### REQUEST FOR INFORMATION (RFI)

PROJECT :	BKK2	R.F.I. NO. :	523213-01-RFI-EL-0007										
TO :	CTA	ATTENTION :	CTA										
SUBMITTED DATE:	20-Jan-26	NEED REPLY BY DATE :	27-Jan-26										
SUBMISSION OF : <input checked="" type="checkbox"/> Q&A <input type="checkbox"/> Drawing <input checked="" type="checkbox"/> Document <input type="checkbox"/> Others (as specified below)													
SUBJECT : Request for Confirmation - Fire Alarm System Interface with Mechanical Equipment													
Total Page (s) : 3 (Including this page)													
<table border="0" style="width: 100%;"> <tr> <td style="width: 25%;">FUNCTION :</td> <td><input type="checkbox"/> Structural (ST)</td> <td><input checked="" type="checkbox"/> Electrical &amp; Communication (EL)</td> <td><input type="checkbox"/> Mechanical (ME)</td> <td><input type="checkbox"/> Vertical Transport (VT)</td> </tr> <tr> <td></td> <td><input type="checkbox"/> Architectural (AR)</td> <td><input type="checkbox"/> Fire Protection (FI)</td> <td><input type="checkbox"/> Hydraulic &amp; Sanitary (HY)</td> <td><input type="checkbox"/> Other (O)</td> </tr> </table>				FUNCTION :	<input type="checkbox"/> Structural (ST)	<input checked

523213-02-DRG-ME-8000, 523213-02-DRG-EL-0170, 523213-02-DRG-ME-8004,  
523213-02-DRG-ME-8005, 523213-02-DRG-ME-8011

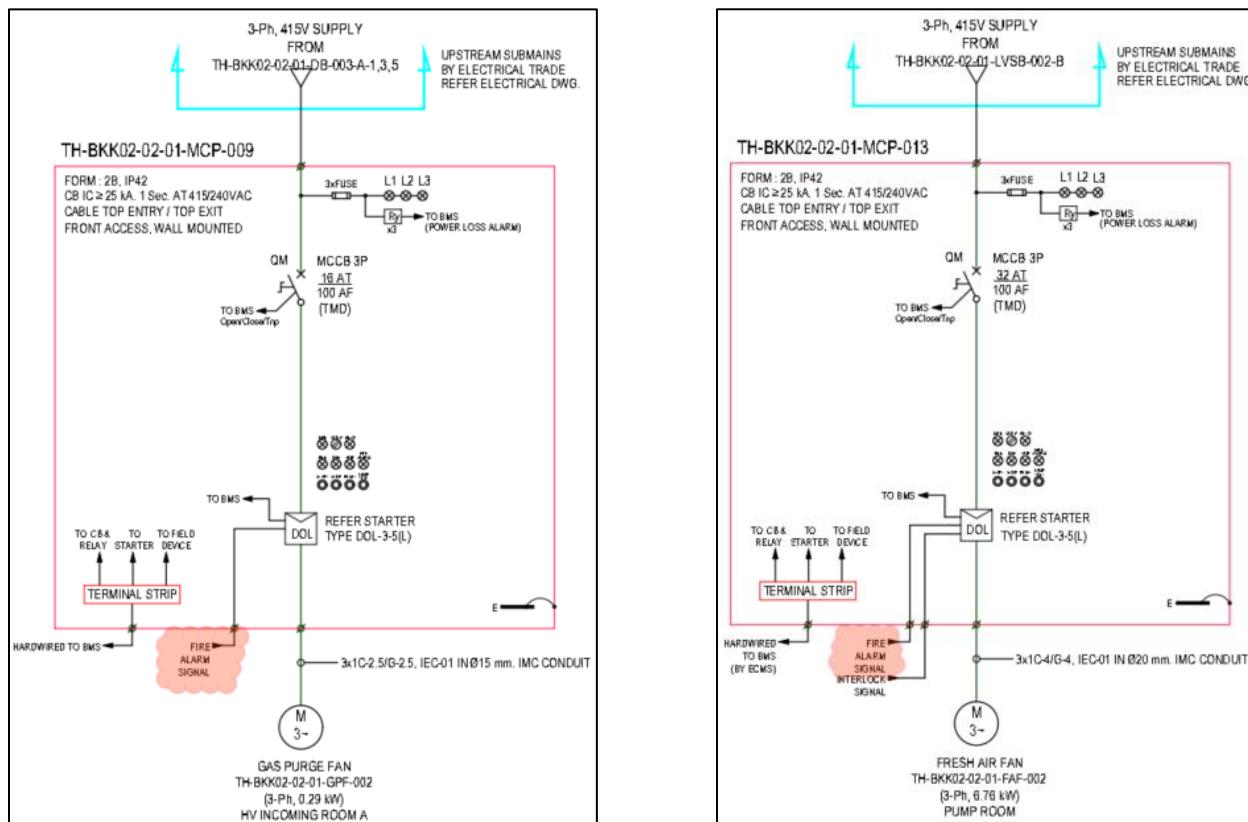
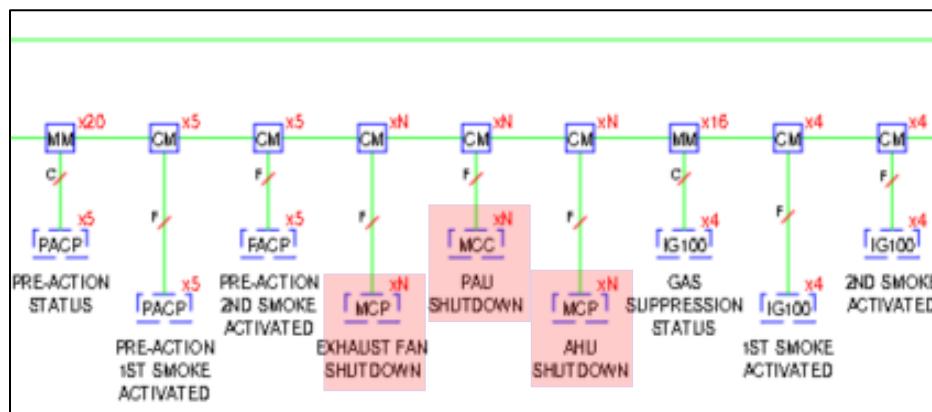
We note that the mechanical drawings specify that Gas Purge Fan (GPF) ,Fresh Air Fan (FAF), ACU-DFCU, FCU required signal from fire alarm system.

However, that signal is not shown in the Fire alarm schematic diagram. Kindly confirm the required signal interface and advise how it shall be implemented.

Not specify interface to Fire Alarm

- Based on the Mechanical drawings, control modules shall be provided to interface with the MCP panels for the Gas Purge Fan (GPF), Fresh Air Fan (FAF), and FCU that require fire alarm signals.
- AUR confirms that the MCP panels for the PAHU require fire alarm signal interfacing.
- The MCP panels for ACU-DFCU do not require fire alarm signal interfacing, as indicated in the Mechanical drawings.

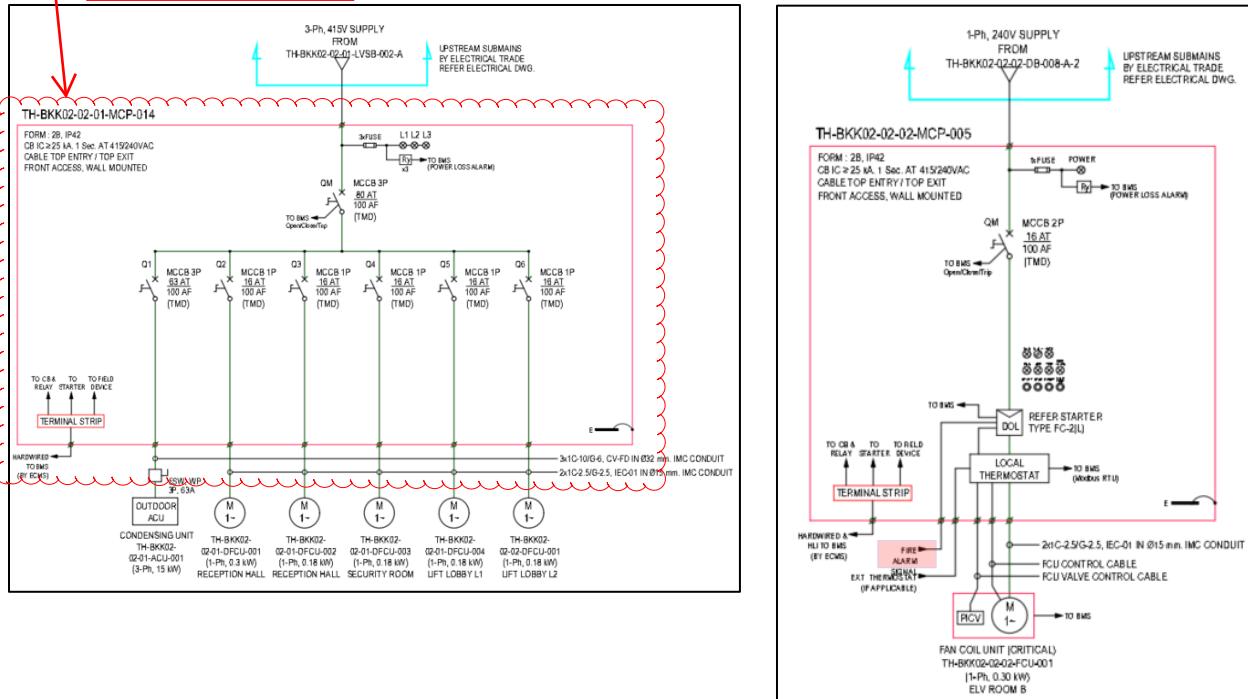
- PAHU not have interface signal but fire alarm schematic indicate a signal.  
Kindly clarify whether the PAHU is required to receive a signal from the Fire Alarm System.
